SKYLINE AT LORSON RANCH FILING NO. 1  
WATERMAIN AND SANITARY SEWER  
CONSTRUCTION PLANS

**AS-BUILT**

PUDSP 21-002

SHEET NUMBER C0.1

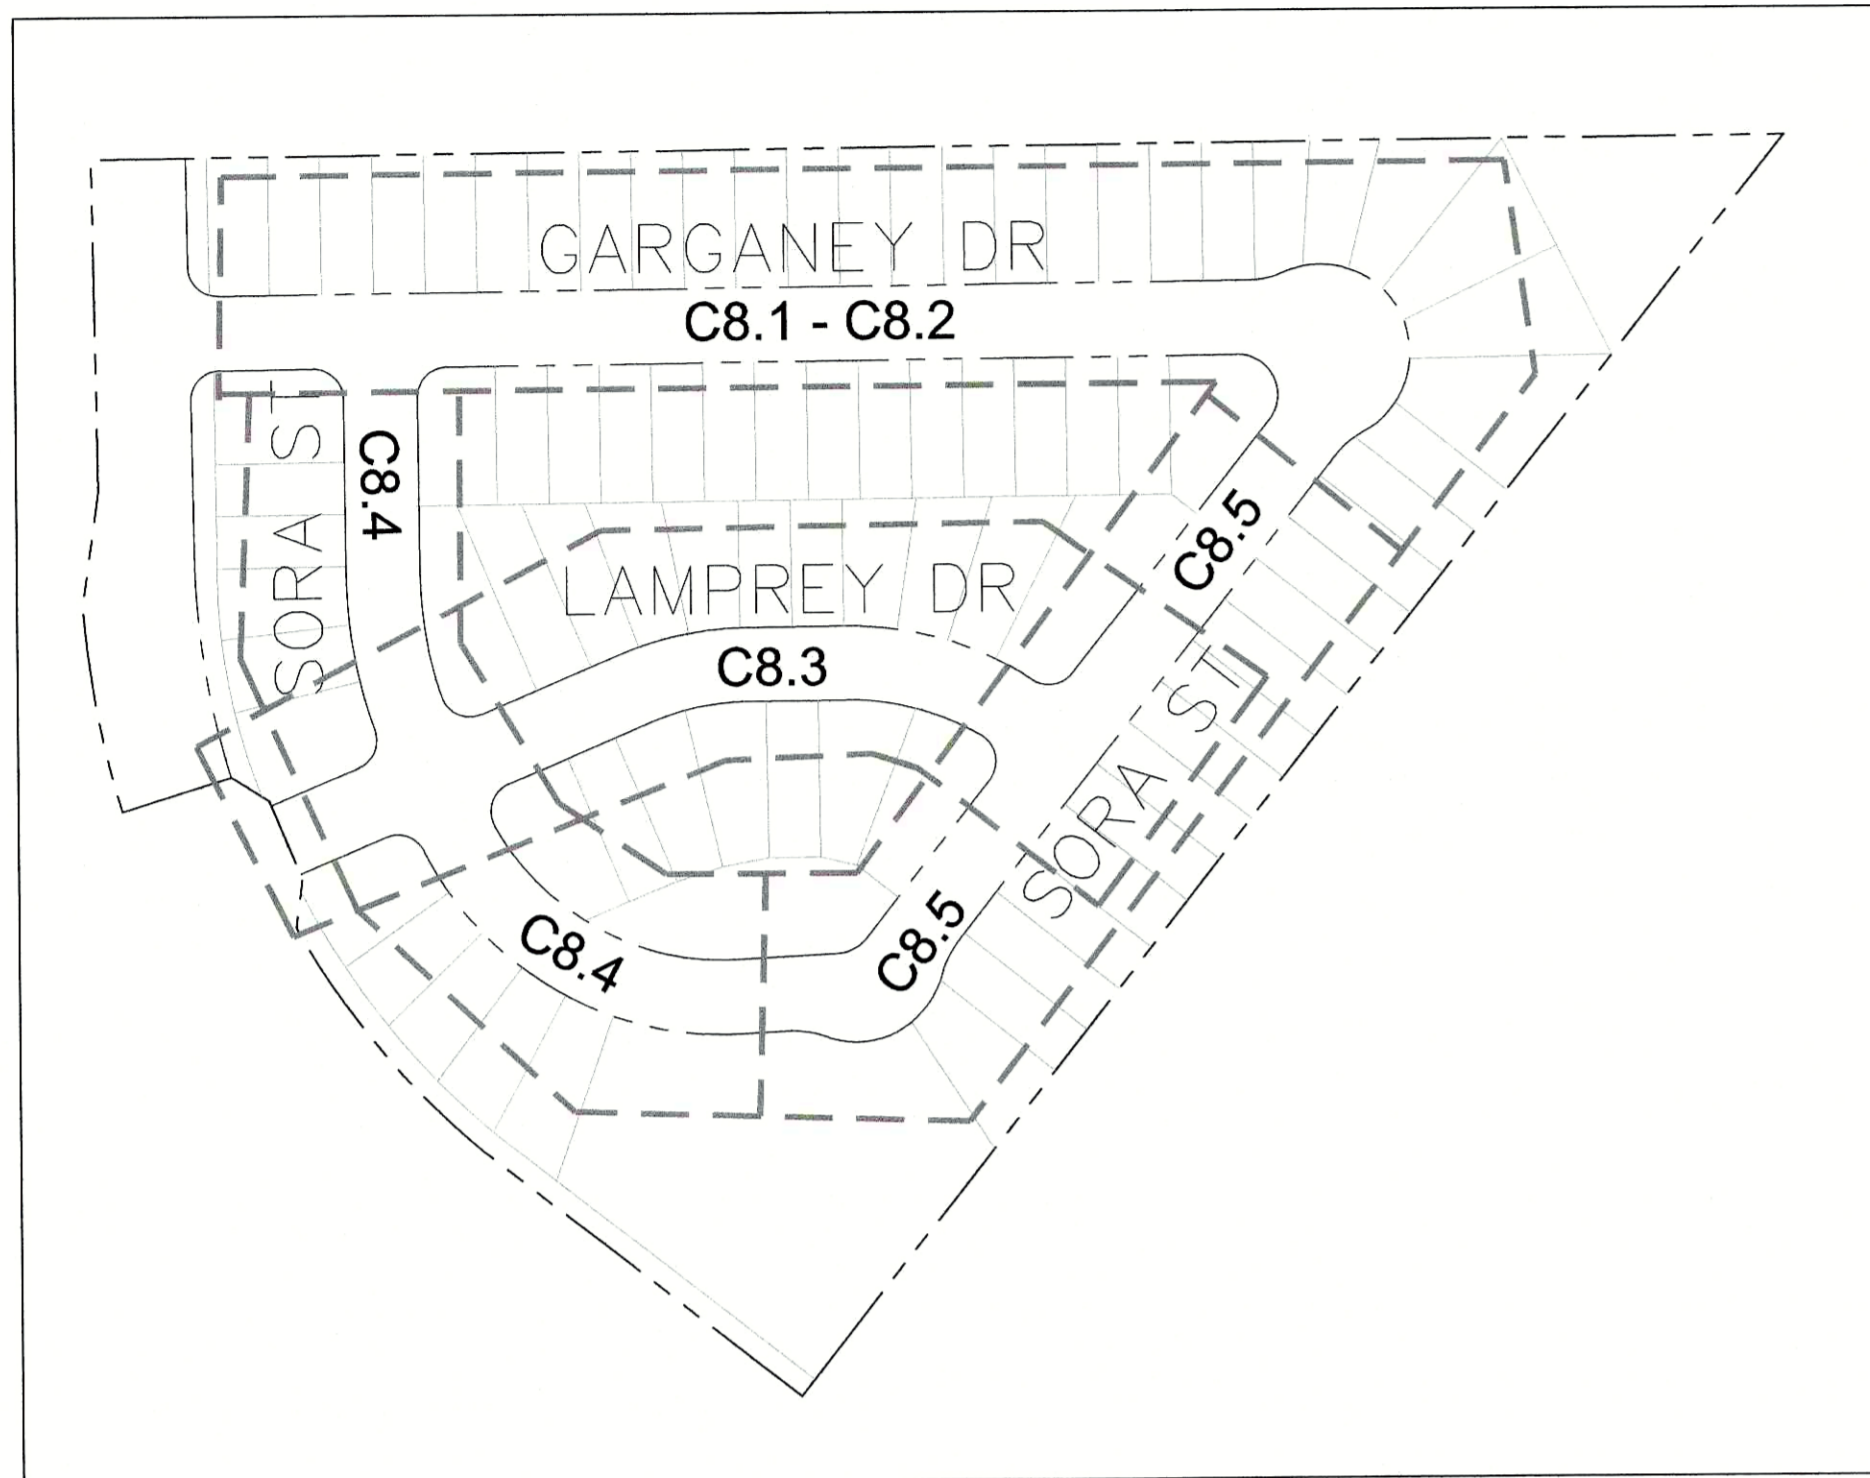
Please submit the most recently approved construction drawings for the as builts. SF221 shows the most recent street and storm sewer CDs dated May 2nd 2022.

Per ECM Chapter 5.10.6.C each sheet of the record drawings shall be designated as "Engineering Record Drawings" and signed and dated by the engineer of record. Please revise to meet criteria.
